SUBJECT: WESTINGHOUSE RESPONSE TO NRC REQUESTS FOR ADDITIONAL  
INFORMATION ON THE NOTRUMP COMPUTER CODE

Question 440.515

Re: NOTRUMP PVR FOR OSU TESTS, LTCT-GSR-001, JULY 1995

Figure 10

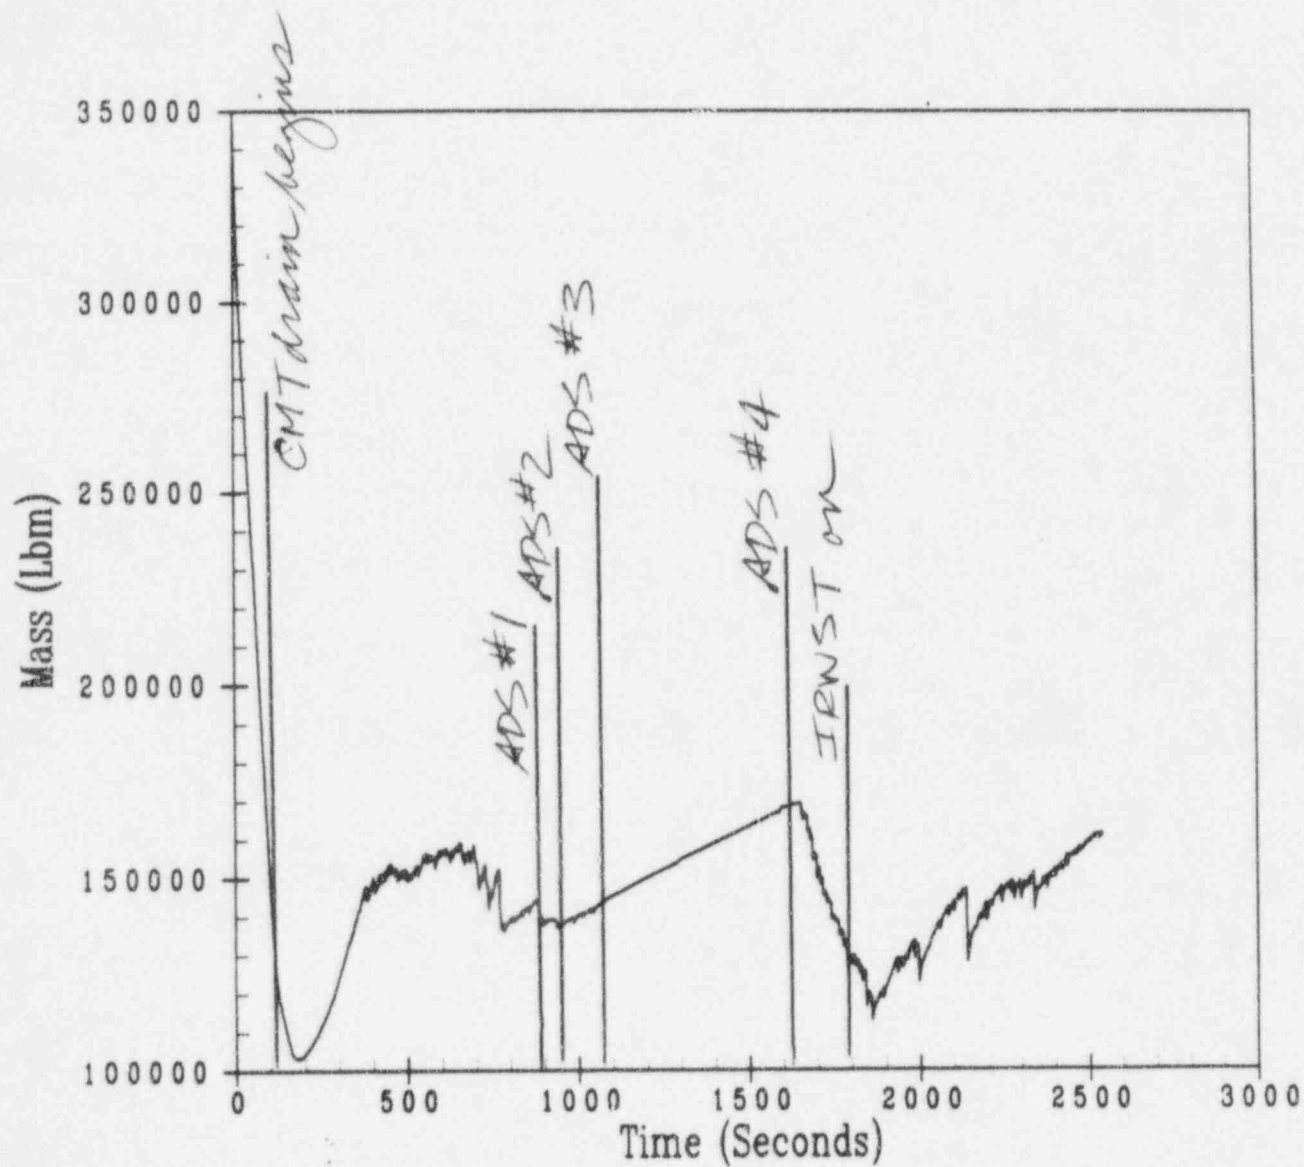
The AP600 has eliminated the loop seal by design, so there is a continual drainage of the reactor coolant inventory into the reactor vessel, particularly at high pressure. Therefore, for the AP600, there is no risk of core uncover due to loop seal clearing occurring at higher pressure as calculated in conventional plants. The minimum core inventory is calculated to occur at lower pressures for the AP600 for the small break LOCA transients with the minimum mass inventory occurring at very low pressure for the smaller breaks. Figures 1 to 3 indicate the reactor system inventory, pressurizer pressure and the upper plenum and core mixture level for a two-inch break in the cold leg. Comparing the figures indicates that the minimum inventory occurs just before the IRWST injection when the system pressure is approximately 25 psia. The upper plenum and core mixture level indicate that substantial margin exists between the top of the core at 18.8 feet and the calculated mixture level. Similar behavior is shown in Figures 4 to 6 for a two-inch balance line break. Similar behavior has also been seen for all smaller cold leg and hot leg breaks. Larger breaks of attached piping such as the double-ended break of the direct vessel injection line (DEDVI) or the double-ended break of the cold leg balance line (DECLBL), cause more rapid depressurization and a minimum reactor system inventory at earlier time and higher pressure. Figures 7 to 12 show similar plots of the reactor system inventory, pressurizer pressure and the upper plenum and core mixture level for these two breaks. The minimum reactor system inventory occurs at approximately 275 seconds for the DEDVI break when the system pressure is approximately 400 psia. The reactor system inventory is rapidly recovered by the accumulator injection. For smaller breaks, the recovery is not so rapid and the system remains at a minimum inventory for longer periods of time. The level in the core and upper plenum indicate that there are periods later than 300 seconds, when the pressure is lower, and the mixture level is the same or lower. A similar behavior is seen for the DECLBL break where the minimum reactor coolant inventory is quickly recovered by the accumulator as shown in Figures 10 to 12.
